Author Response for Submission “PushAround: Collaborative Path Clearing via Physics-Informed Hybrid Search”

To Associate Editor

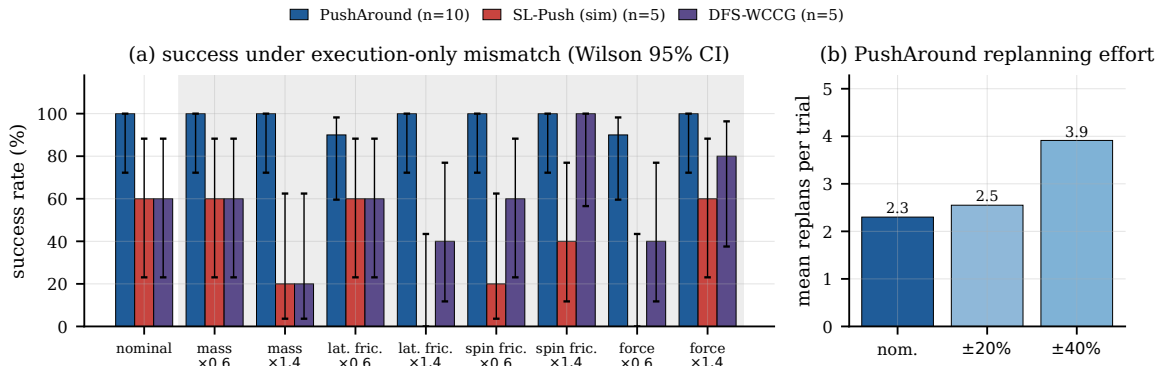
Q: *The method relies heavily on simulation-based feasibility validation, but sensitivity to uncertainty in mass, friction, force limits, contact dynamics etc. is not systematically evaluated.*

A: We agree that this was the most substantive gap, because physics validation is the distinguishing element of the method. The original hardware experiments demonstrated closed-loop recovery but did not *isolate* sensitivity to individual model parameters. The revision therefore adds a dedicated planner–execution mismatch study with two properties that make the claim falsifiable:

Over 17 conditions ($M=30$, $N=2$, 10 seeds each, 170 trials) PushAround succeeds in **166/170 (97.6%)**, and importantly the success rate does *not* degrade with the perturbation magnitude: **78/80 (97.5%)** at $\pm 20\%$ and **78/80 (97.5%)** at $\pm 40\%$, versus 10/10 nominal. The four failures are one mid-execution planning failure (lateral friction $\times 0.6$) and three trials that exceeded the per-trial budget (spin friction $\times 1.2$, force limit $\times 0.6$ and $\times 1.2$). Replanning absorbs the remainder: mean replans rise from 2.3 (nominal) to 3.9 ($\pm 40\%$ average; up to 8.1 under force limit $\times 0.6$), where the weaker pushing force shortens the reachable force range and lengthens execution from 104.7 s to 159.6 s.

Second, to show that this robustness is a property of the method rather than of the scene, we ran SL-Push (sim) and DFS-WCCG under the same protocol (nominal planning, execution-only perturbation, 5 seeds per condition). Under the identical $\pm 40\%$ perturbations, SL-Push (sim) attains **13/40 (32.5%)** — with 0% under lateral friction $\times 1.4$ and force limit $\times 0.6$ — and DFS-WCCG **23/40 (57.5%)**, while requiring $\sim 12\times$ more planning time (mean 229 s versus 18 s). Both baselines are already weaker at nominal physics (3/5 each versus 10/10), which is consistent with the main comparison in Table II.

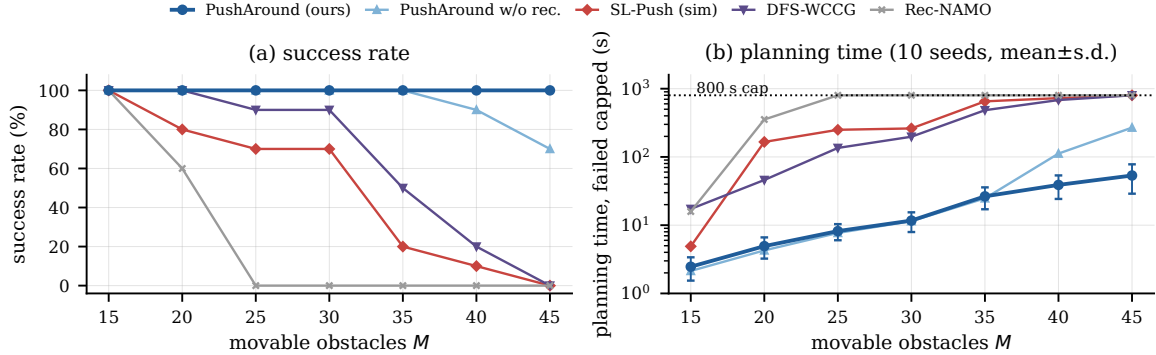
Q: *Although the method is tested with up to 45 movable obstacles, the number of independent trials is limited.*

A: We agree, and we have both increased the number of independent runs and changed how the results are reported.

- The density sweep now uses **10 independent seed sequences** per density instead of five (7 densities $\times$ 10 seeds = 70 PushAround trials). For each seed the denser instances are generated incrementally, while different seeds are generated independently, so the success-rate estimates at neighbouring densities are paired but the seeds themselves are not.
- Fig. 10 now shows the success rate and the mean planning time with one-standard-deviation whiskers; Table III lists PT and ET as mean $\pm$ s.d. Failed and pruned baseline trials are assigned

- All headline success rates are reported with Wilson 95% intervals in Fig. 8. For PushAround at $M=45$ the interval is $[72.2, 100]\%$ from 10/10; for the baselines at the same density it is $[0, 27.8]\%$ from 0/10.

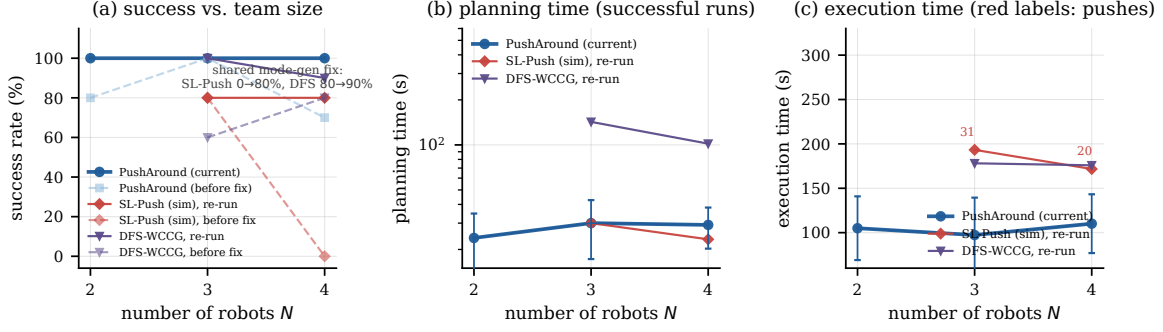
Q: The experiments primarily use two robots. What happens when the number of robots increases with the complexity of the task? How does the search and the contact/force formulation scale to larger robot teams?

A: This question turned out to be more productive than expected. It exposed a mode-generation bottleneck, we fixed it, and the re-run — performed on *both* PushAround and the baselines with identical code — shows that the fix lives in the shared mode generator rather than being a PushAround-only behaviour. The corrected comparison is reported below.

Bottleneck, fix, and who benefits. The preliminary $N=4$ runs failed in 3 of 10 seeds (2 planning failures, 1 budget timeout). Diagnosis: for some push tasks *no* full-team contact assignment exists — small pushable faces, or the pairwise pusher-clearance constraint rejecting every remaining candidate of one robot — and the legacy greedy replacement was additionally sensitive to robot ordering. We added two mode-generation-local refinements that leave global planning, task sampling and the search tree unchanged: (i) *bounded backtracking* contact assignment and (ii) a *temporary per-task robot release* (up to one robot is excluded for that single push and holds its pose, a penalty is charged during mode ranking so full-team modes are preferred, and the full team is re-available for every later task).

After the fix, all three methods solve 80–100% of the team-size trials, so *we no longer claim that the baselines degrade with team size*, and the success-rate differences at $N=3,4$ lie within overlapping Wilson intervals (at $N=4$: PushAround $[0.72, 1.00]$, DFS-WCCG $[0.60, 0.98]$, SL-Push (sim) $[0.49, 0.94]$). What remains separated is (i) *consistency*: PushAround is the only method with

Figure 7: WCCG validation. (a) Agreement per category: CC and FR differ on 4 of 300 scenes (all raster-unstable), whereas WCCG matches the continuous reference on all 300 with zero false positives/negatives. (b) Mean connectivity-query cost on a logarithmic scale.

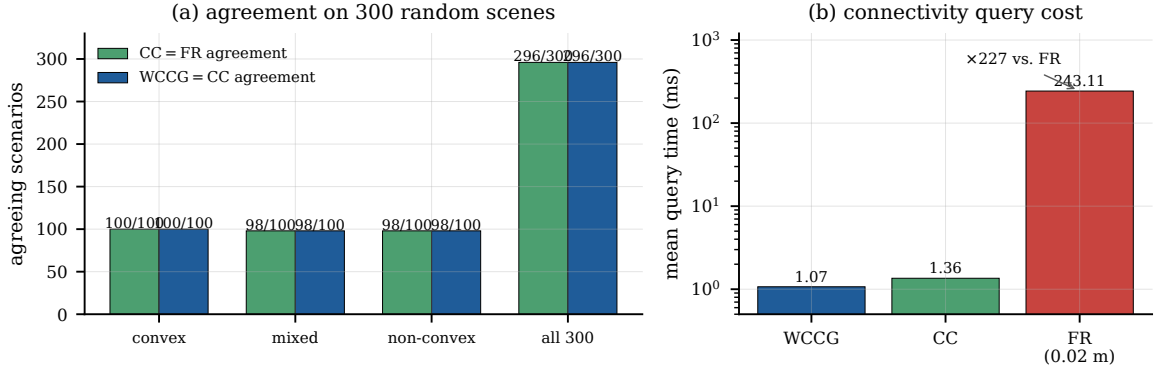
Q: The WCCG connectivity condition is important since it is used throughout the search and also determines termination. The intuition is reasonably clear, but the paper would benefit from a little more justification here, or perhaps a comparison with a standard configuration-space connectivity check. This seems especially relevant when the obstacles are non-convex.

A clearance-connectivity query is conventionally answered by inflating the obstacles by $W/2$ and then testing connectivity either on an occupancy grid (BFS/A* or a distance transform) or with a sampling-based roadmap (PRM/RRT-style). Both are correct given sufficient resolution or samples, but each fixes a resolution or a sample count, must be rebuilt whenever an obstacle moves during clearing, and returns a binary answer only. WCCG is built directly from the obstacle geometry instead: every clearance-critical closest-point pair becomes an annotated bridge, so a query returns not only whether the start and goal are W -clear-connected, but also, when they are not, the *bottleneck gap* that separates them and the frontier sequence that PIHS should clear next. That gap graph is what the search consumes, and a grid or roadmap query would have to be post-processed to recover it. The same-face rule is simply the concrete query we apply to this graph, and it follows from the standard inflation interpretation: inflating by $W/2$ turns every gap narrower than W into an overlapping barrier, so two points are W -clear-connected exactly when they lie in the same face of the embedded graph. Non-convex obstacles are handled by the clearance-relevant convex decomposition of Sec. III-A2 (Page 3), which is why the validation below separates convex, mixed and non-convex scenes.

Because degenerate geometry and decomposition choices still matter in practice, we also compare WCCG against two independent references on 300 random scenes stratified into convex, mixed, and non-convex obstacles: a continuous configuration-space (CC) reference and a rasterized reference (FR) at 0.02 m, verified at 0.01 m. CC and FR disagree in **4/300** cases, all of which are raster-unstable near narrow or tangential contacts. On all 300 scenes, WCCG agrees with the continuous reference and produces **zero false positives and zero false negatives** — a false positive would be the dangerous case, as it could terminate PIHS prematurely. WCCG additionally answers a query in **1.07 ms** on average, comparable to CC (1.36 ms) and **227×** faster than FR (243.1 ms), while supplying the gap graph that PIHS consumes.

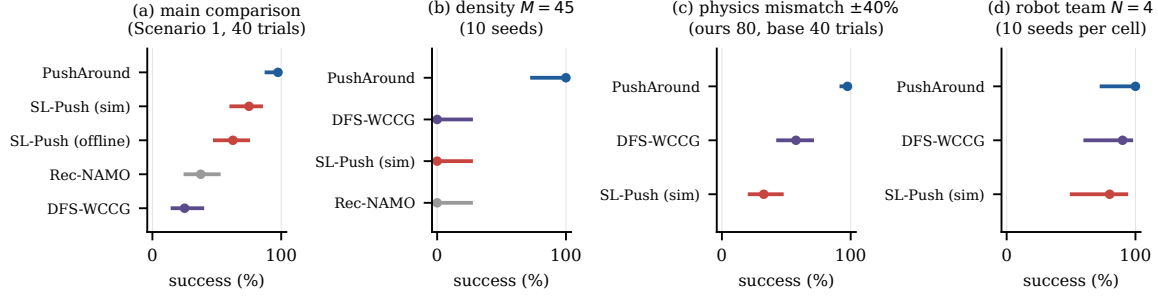
Q: *A few more implementation details, such as robot reachability checks, timeout limits, and computation budget, would make the comparison easier to interpret. I would also suggest adding error bars or standard deviations, particularly for the scalability experiment where only five seeds are used for each obstacle density.*

- The density sweep, the robot-team study (all policies) and the mismatch study for PushAround use 10 seeds per cell; only the *mismatch* baseline supplements use 5 seeds and are labelled as such. Fig. 8 reports Wilson 95% intervals for every headline number, and Table III in the manuscript reports $\text{mean} \pm \text{s.d.}$

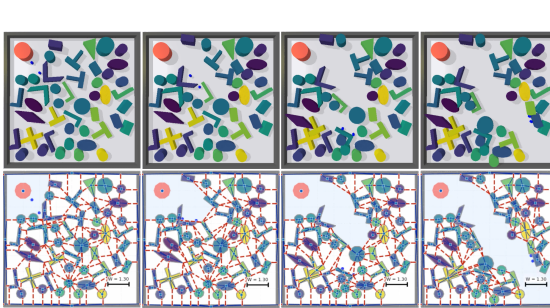
(a) Original: one overlay inset did not match its snapshot.

(b) Revised: regenerated with the correct inset.

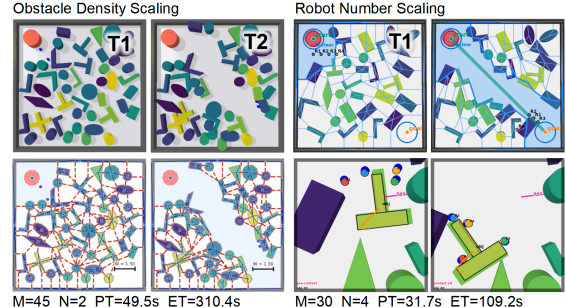
(a) Original: obstacle-density run only.

(b) Revised: density run (left half) plus the four-robot study (right half).
